# HISTORIC AND DESIGN REVIEW COMMISSION

February 01, 2023

**HDRC CASE NO:** 2022-544  
**ADDRESS:** 354 NORTH DR  
**LEGAL DESCRIPTION:** NCB 7014 BLK LOT 18, E 5 FT OF 17 & W 5 FT OF 19  
**ZONING:** R-6, H  
**CITY COUNCIL DIST.:** 7  
**DISTRICT:** Monticello Park Historic District  
**APPLICANT:** Luis Valderas  
**OWNER:** Luis Valderas  
**TYPE OF WORK:** Roof replacement and roof form modification to rear accessory structure  
**APPLICATION RECEIVED:** January 06, 2023  
**60-DAY REVIEW:** Not applicable due to City Council Emergency Orders  
**CASE MANAGER:** Jessica Anderson

1. Replace the existing composition shingle roof on the garage with a corrugated metal roof to match the patio cover and the rear accessory structure.
2. Modify the front gable roof form to a flat roof form and raise the height of the top plate of the garage.

## 354 North Drive garage & roof repair drawings

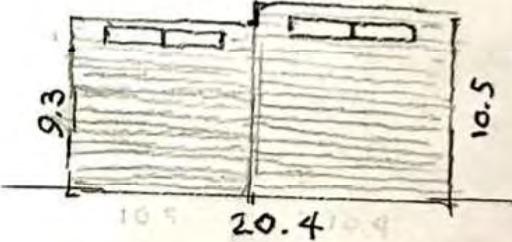
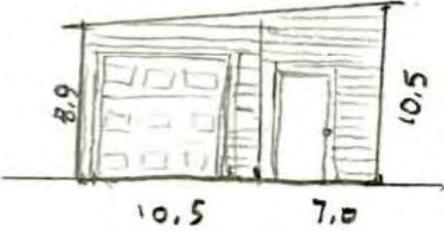
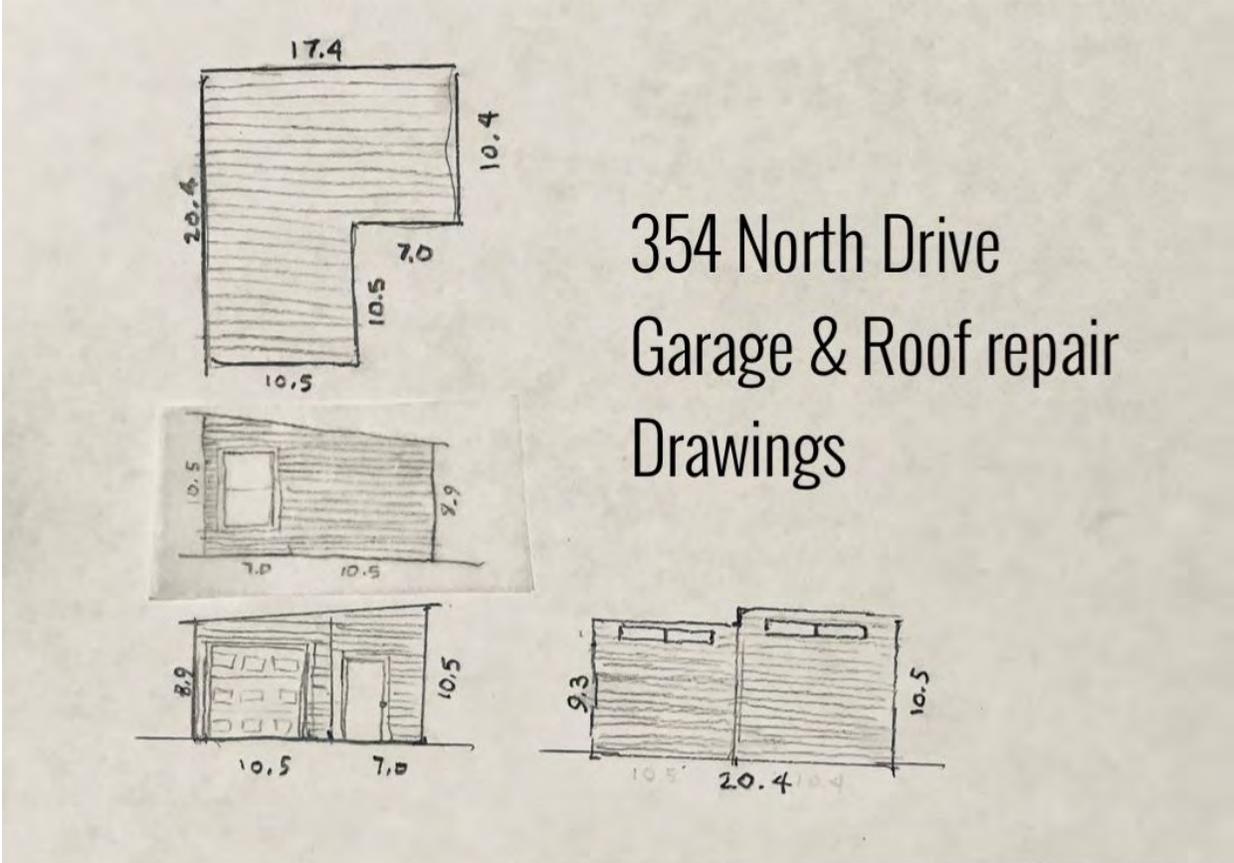
- d. ROOF: MATERIALS – The applicant has proposed to replace the composition shingle roof with a corrugated metal roof to match the existing patio cover. Guideline 3.B.iv for Exterior Maintenance and Alterations states that roofing materials should be replaced with in-kind materials whenever possible when the roof must be replaced. Historic materials such as slate or clay tiles should be retained and re-used when large-scale replacement of roof materials other than asphalt shingles is required. The existing clay roof tiles are severely damaged and require replacement. Furthermore, Guideline 3.B.iv states that new roofing materials should match the original materials in terms of their scale, color, texture, profile and style or materials should be selected that are consistent with the building style when in-kind replacement is not possible. Per the 1951 Sanborn Map, the roofing material at that time was a composition shingle roof. Staff finds the proposal inconsistent with the Guidelines.

- e. ROOF: FORM – The applicant has proposed to modify the front gable and shed roof forms to a flat roof form to match the existing rear carport structure and to raise the top plate height. According to Guideline 3.B.ii for Exterior Maintenance and Alterations, the original shape, line, pitch, and overhang of historic roofs should be preserved when replacement is necessary. Additionally, Guideline 3.B.iii states that distinctive roof features such as cornices, parapets, dormers, open eaves with exposed rafters and decorative or plain rafter tails, flared eaves or decorative purlins, and brackets with shaped ends should be preserved and repaired. Staff finds the proposal inconsistent with the Guidelines and finds that the original roof form should be preserved.

Item 1, staff does not recommend approval of the roof material change on the rear accessory structure based on findings a through d. Staff recommends that the applicant installs a replacement composition shingle roof to match the previously existing roof.

Item 2, staff does not recommend approval of the roof form modification based on finding e. Staff recommends that the applicant retains the front gable and shed roof forms.
